APPENDIX IV
DETAILS OF CASK RESPONSE TO FIRE ACCIDENTS

DETAILS OF CASK RESPONSE TO FIRE ACCIDENTS

Figure IV-1. CAFE three-dimensional domain: (a) CAFE regulatory fire, (b) cask on ground and at the center of the pool, (c) cask on the ground and 3m (10ft) from the edge of the pool, (d) cask on the ground and 18.3m (60ft) from the edge of the pool.

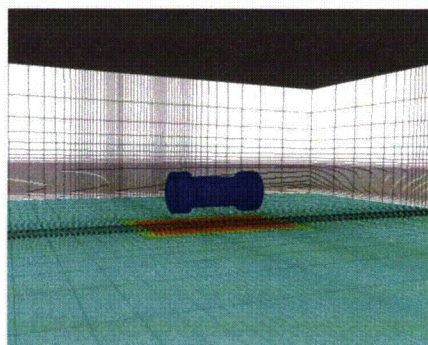
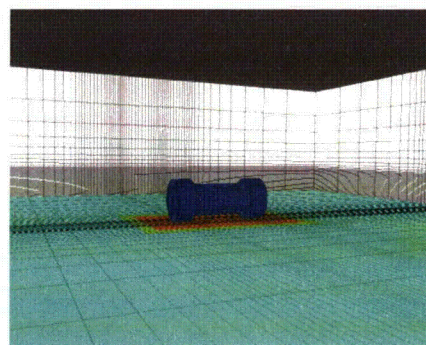
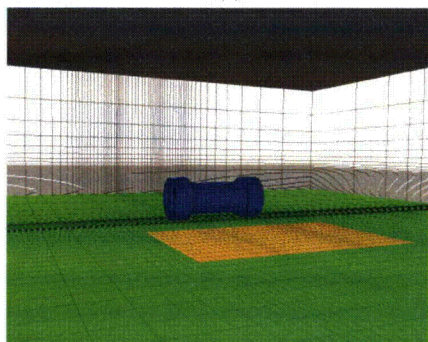
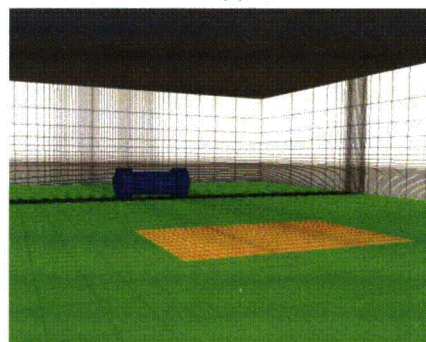
Comment [XXX3]: Are they square or rectangular?

Figure IV-4. Rail-Steel cask overpack: (a) cross-sectional view through the center of the cask, (b) cross-sectional view through the mid-plane of the overpack (Holtec 2004).

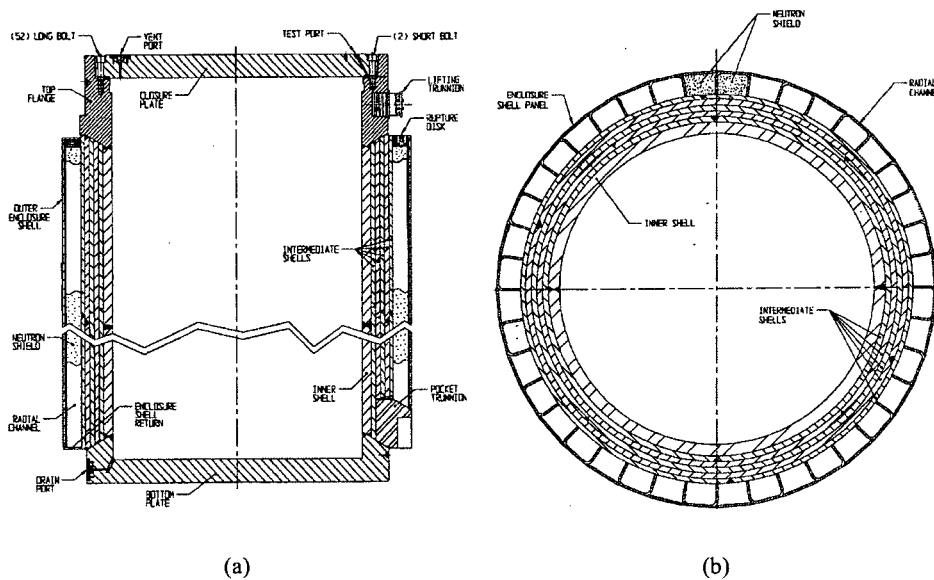
Comment [XXX4]: Provide additional justification or discussion.

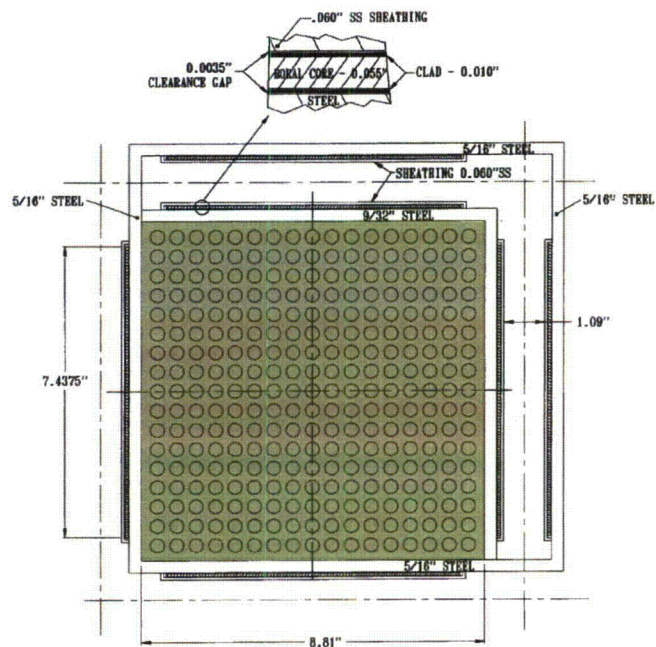
Comment [XXX7]: Provide additional discussion of calculation of equivalent diameters.

Comment [XXX8]: Should this be IV-8?

Figure IV-9. Rail-Steel cask finite element mesh (model is symmetric, only half modeled).

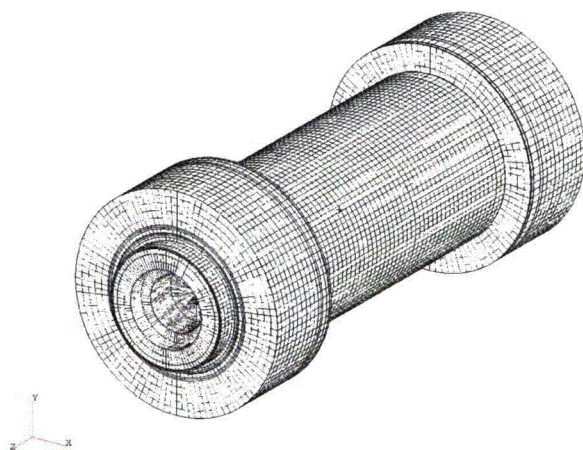
Comment [MF18]: Appears entire model is shown – not half.

Figure IV-18. Three-dimension, quarter section of the directly loaded basket. The helium material is not shown.

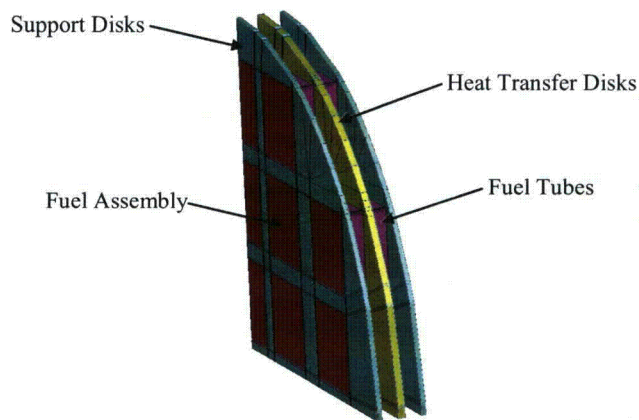
Comment [MF20]: One disk or two?

Figure IV-19. The Rail-Lead cask mesh (mesh is symmetric, only half modeled).

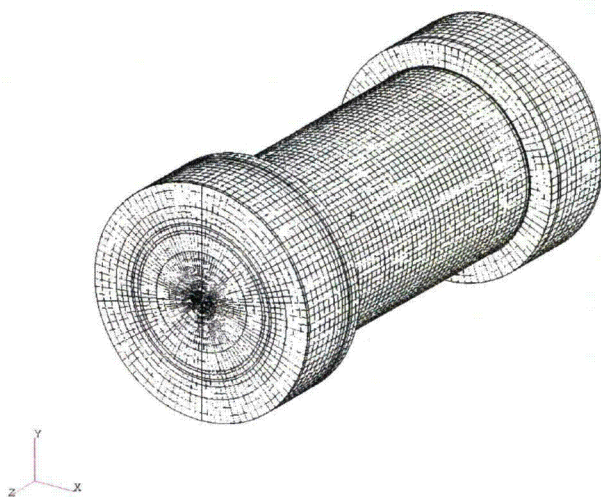
Comment [MF21]: Appears to be full cask, not half
